Compilation of Key Documents Pertaining to the
Structural Evaluation of
Seabrook Nuclear Power Plant

PROF. VICTOR E. SAOUMA
University of Colorado, Boulder

C-10 RESEARCH AND EDUCATION FOUNDATION
Newburyport, MA

This documents contains the major submittal by C-10 to the Nuclear Regulatory Commission (NRC) in connection with the contested license renewal of *Seabrook Station Unit No. 1 Issuance of Amendment No. 159 Re: Methodology for Analysis of Seismic Category I Structures With Concrete Affected by Alkali-Silica Reaction (CAC NO. MF8260; EPID L-2016-LLA-0007)*¹ that is known to suffer from Alkali Aggregate Reaction² Additional related documents can be found [here](#).

Figure 1.3: Representativeness of the FSEL tests

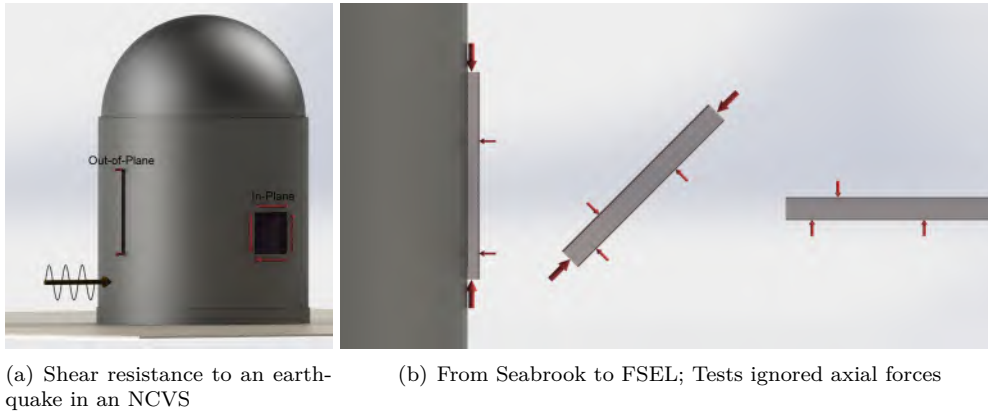
1. What is at stake is the response of the NCVS when subjected to a **lateral seismic load** (ground motion). This will subject it to shear forces that must be resisted.
2. The (cylindrical) container will resist shear through two mechanisms: a) **Out of plane** shear at the azimuth along the earthquake; b) **in plane** shear at 90 degrees; and c) a combination of the two in between, Fig. 1.3(a).
3. In both cases, relevant concrete tests should subject their specimens to large **normal compressive stresses** caused by the weight of the dome and wall above the lower portion of the cylinder (where shear is highest, Fig. 1.3(b)).

Limited Applicability Only out of plane shear tests were performed (Fig. 1.3(a)). Even setting aside the questionable applicability of these tests results, they are only applicable in a narrow zone of the NCVS, Fig. 1.3(a).

Figure 1.4: Some problematic observations

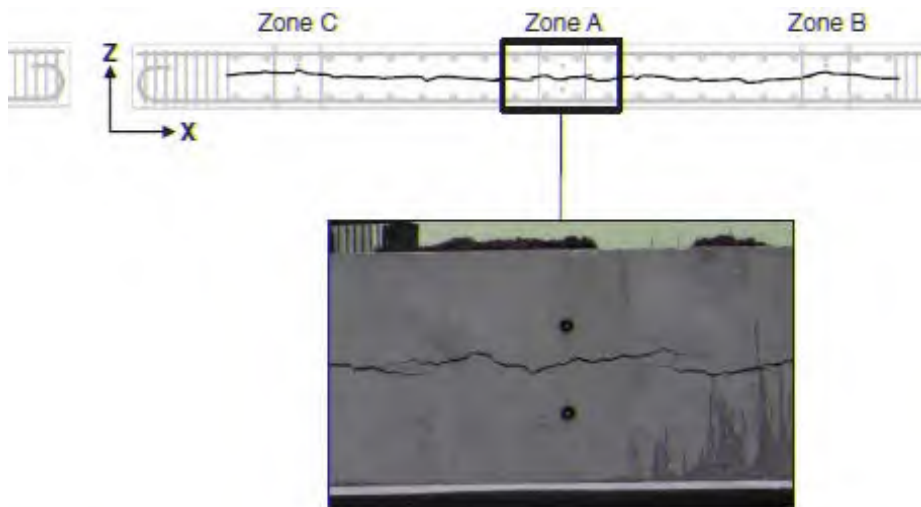
Observed Crack As ASR developed in the test specimens, a large crack was noted in the center of the surfaces of the beam that were between the reinforcement mats. Figure 4-2 is a photograph, Fig. 2, showing the large crack in one of the beam specimens, (**MPR-4288**). This unanticipated large crack on specimen edge (**MPR-Tests-2**) is of major concern. Though mentioned in the report, there is no explanation as to what may have caused it, nor the possible impact it could have on the test results.

Figure 2.5: “Shear” crack formation locations and corresponding load displacement response; Test probably was intended to have a crack in the top figure (green), but ended up occurring in the location shown below (red).

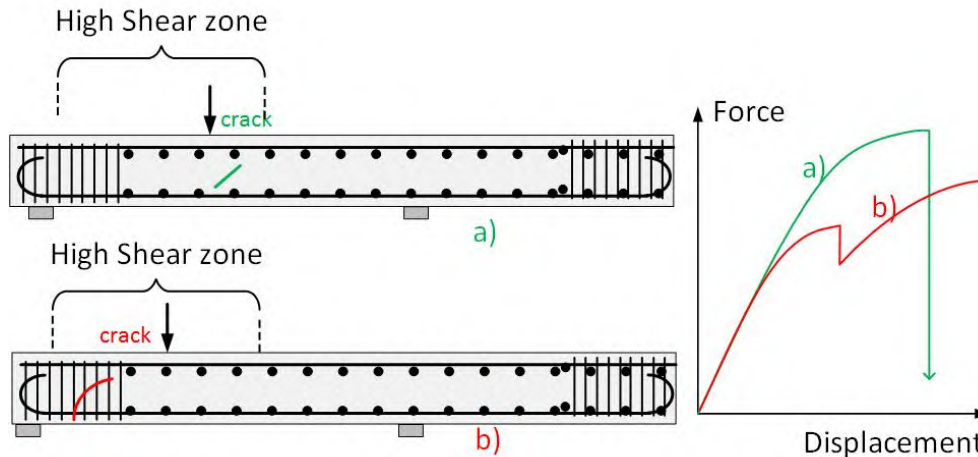
What is likely to have occurred is a crack in the zone of the beam with the shear reinforcement (as shown in Figure 2.5-b) which would cause a load displacement curve as the one reported. Thus, there is a very strong suspicion that shear did not occur where it was supposed to be, but in a reinforced region. Hence there was NO SHEAR FAILURE as intended.

Figure 2.8: Reported Large Crack from Surface between Reinforcement Mats
(wald2017expansion)

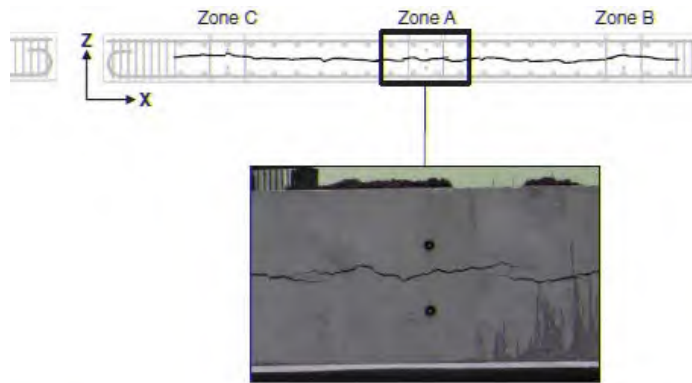
Such an unanticipated crack, shown in Figure 2.8, should be of the utmost concern as it jeopardizes the representativeness of the ensuing test.

There is a very simple explanation (regretfully, none was provided in the report) as to what most likely has happened. Figure 2.9 provides an illustration. Expansion is restrained along the beam in the X and Y axis, but not in the Z axis. Hence ASR volumetric expansion was nearly entirely channeled into the Z direction and unsurprisingly cracked the beam. This is not unlike the delamination crack (between reinforcement mats) that occurred at Crystal River (though for entirely different cause), Figure 2.10.

Figure 3.3: LSTP is a model test and not a prototype test, there will be a [redacted] reduction in shear strength in Seabrook. Adapted from bentz2005.

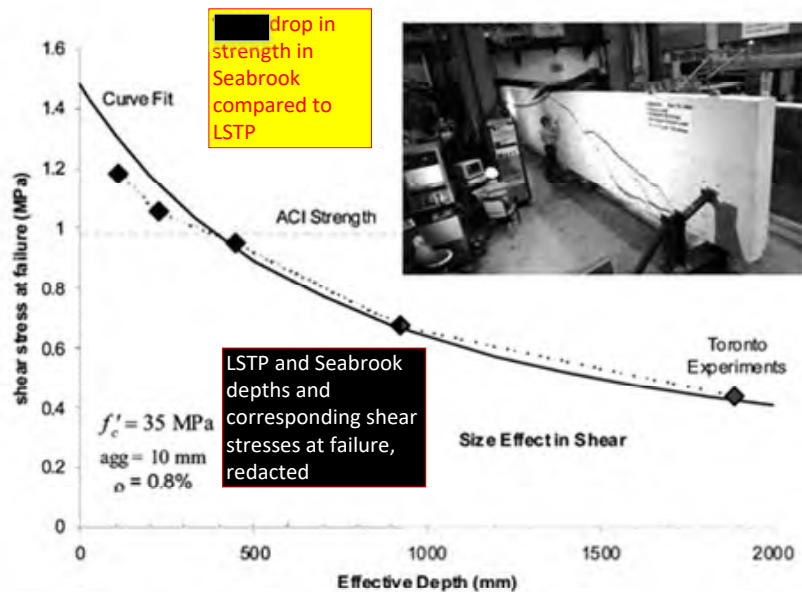
Another important difference between the test specimen and the CEB is that the test specimen was about [redacted] scale ([redacted] depth whereas the wall of a CEB is about 36 inches). This is not unusual in component testing. However, given the brittle nature of shear failure and associated size effect, the shear strength in the CEB will be lower than the one from the LSTP. This phenomenon is described by Figure 3.3, a depiction of the LSTP derived from bentz2005.

Figure 3.22: Uncertainty in the determination of the Elastic modulus from the compressive strength as proposed by NextEra [PROPRIETARY INFORMATION]

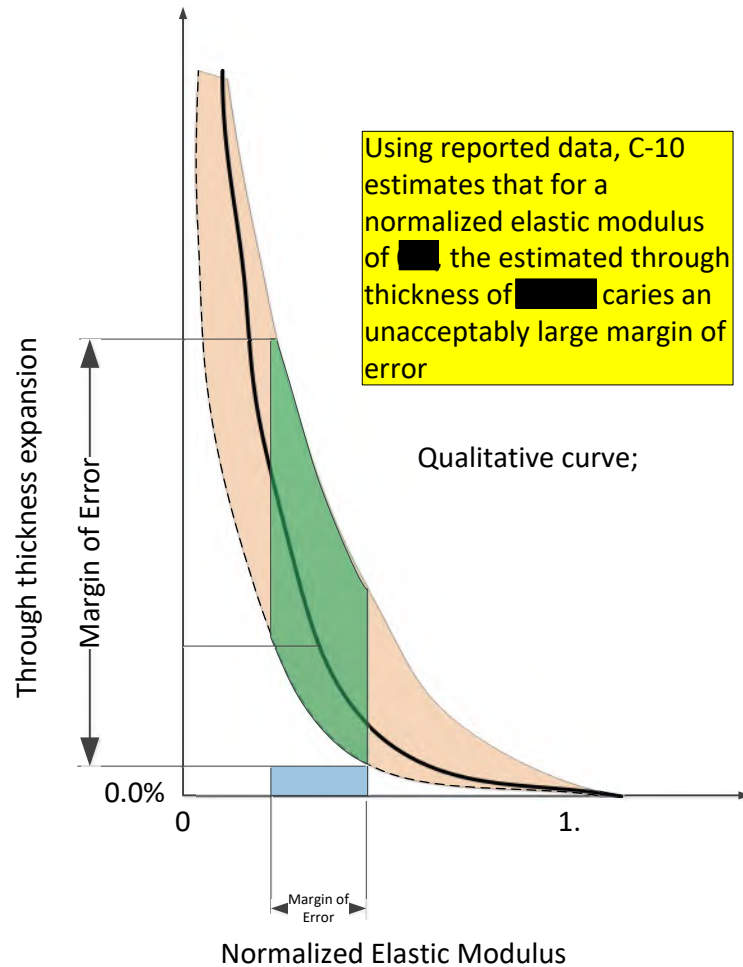
I analyzed the impact of both uncertainties, Figure 3.19 and Figure 3.20 to determine what would be the possible margin of error in NextEra’s curve (shown in Figure 3.21). The result is shown in Figure 3.22. The approach is described next:

7. In Figure 3.22 we go up the y axis to determine the through thickness, and note that it would be somewhere between ■■■% and ■■■%.

Figure 4.2: Impact of ignoring the concrete strength increase over time.

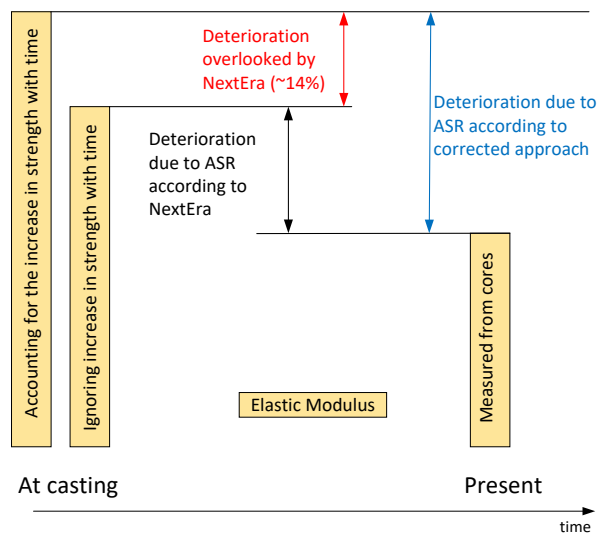
The impact of NextEra's and MPR's oversight is further illustrated in Figure 4.2 below. Taking into consideration the increase in compressive strength during the first two years after casting the Seabrook concrete, the actual amount that compressive strength has been lost due to ASR will be substantially more than the loss estimated by NextEra and MPR using the corroboration study in its current form. In other words, the extent to which ASR has damaged the concrete at Seabrook will be much greater than the extent that will be estimated by MPR's method. Hence, the corroboration study will not yield meaningful results if it fails to account for the fact that the compressive strength of Seabrook concrete was initially much greater than assumed.

Figure 4.3: Adjusted relationship between through-thickness expansion and the corrected normalized elastic modulus

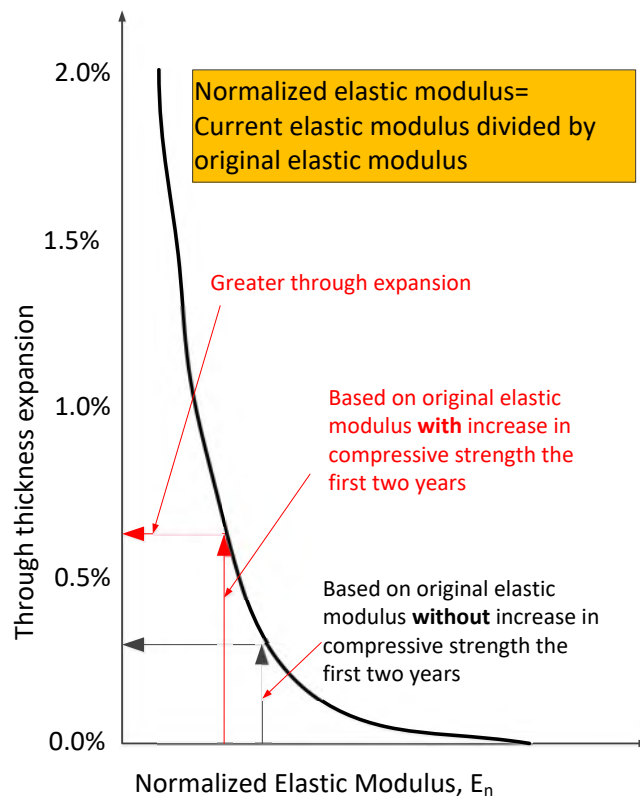
This new information about the increase in compressive strength also affects my original Figure 22 (page 40 of my Rebuttal Testimony). In Figure 4.3 below, I have modified Figure 22 to account for the increase in the compressive strength. The curve for the normalized elastic modulus is shifted to the left, while maintaining the same margin of error. (Note that I have removed the errors bars to facilitate understanding). Because the through thickness is indeed very sensitive to the normalized

elastic modulus (see Figure 21 at page 38 of my Rebuttal Testimony¹), this will result in an even greater through thickness expansion than predicted by NextEra.
